Workshop Campaign EA02

Transaction No.: 2035328/2

Flying Spur HVAC refrigeration pipe clip replacement - Corrosion (SC14/02)

Figure 1

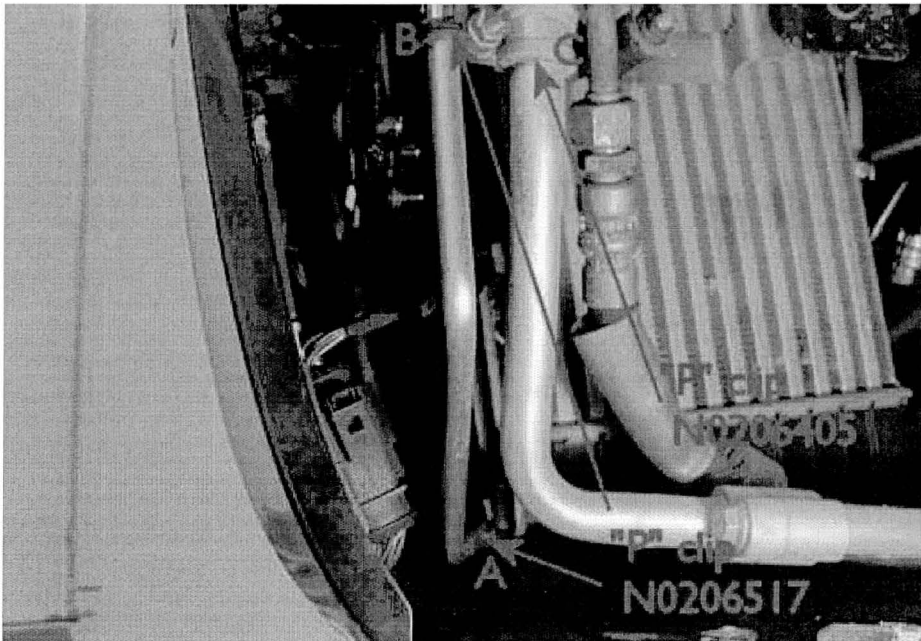
5. Referencing figure 1 identify the three P clips (A,B and C) located in the front left wheelarch that require replacement

9. On cars where the pipe is serviceable, figure 3, fit three replacement clips. For position A and B fit new clip part number RSGUV1.10-15W1 in position C fit new clip part number RSGUV1.18-15W1. If either pipe is found to have extensive corrosion then both pipes should be replaced before replacing the clips, in this case follow the *Air conditioning pipe replacement* procedure detailed below.

Figure 2

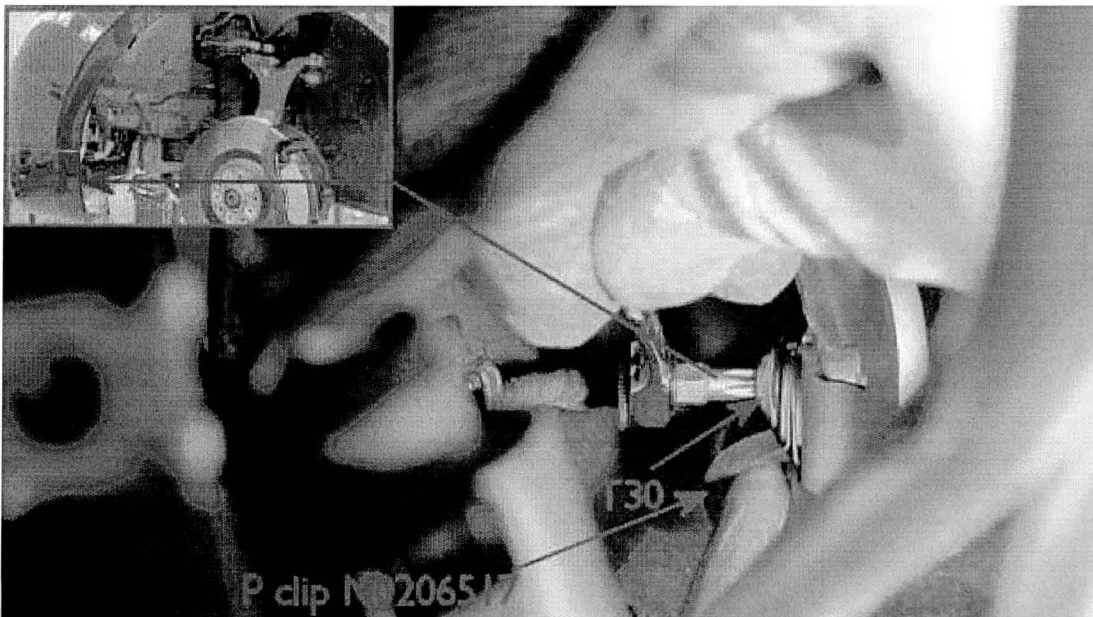
6. Using a T30 bit loaded into a ratchet spanner remove the fastener securing P clip (A). Remove and discard clip A (see Figure 1 and 2)
7. Remove and discard clips B and C (see Figure 1)

Figure 3

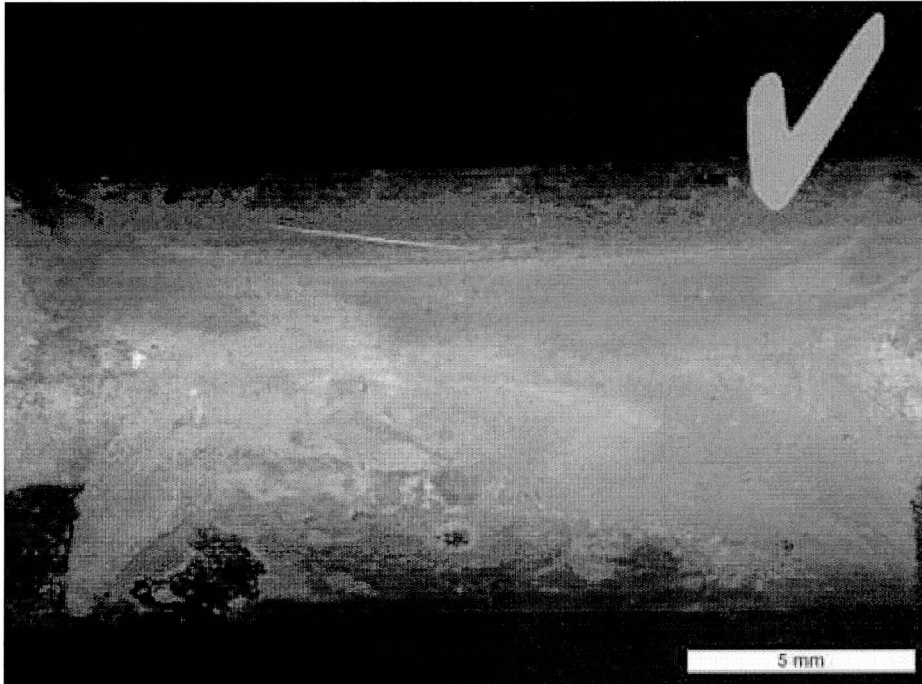
corrosion, use of a mirror will aid inspection. Discolouration and light oxidation on the surface of the pipe is not detrimental and does not necessitate pipe replacement (see Figure 3). If the pipe surface shows signs of extensive corrosion and pitting (see Figure 4) then that pipe should be replaced

Figure 5

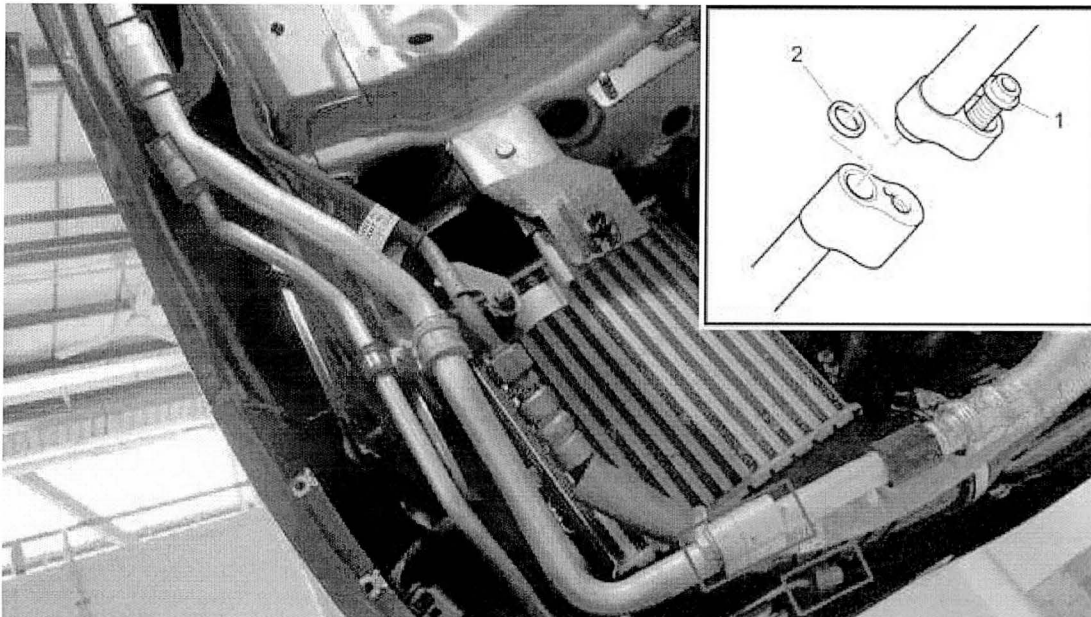
2. Locate the four joints securing the two pipes (see Figure 5). For each of the four joints remove the retaining screw -1- then separate the two pipes, discard the O ring -2-

3. Fit the two new pipes using new O rings coated in refrigerant oil. Tighten pipe joint retaining bolt -1- to 15Nm
 4. Fit and secure the pipes using the three new pipe clips
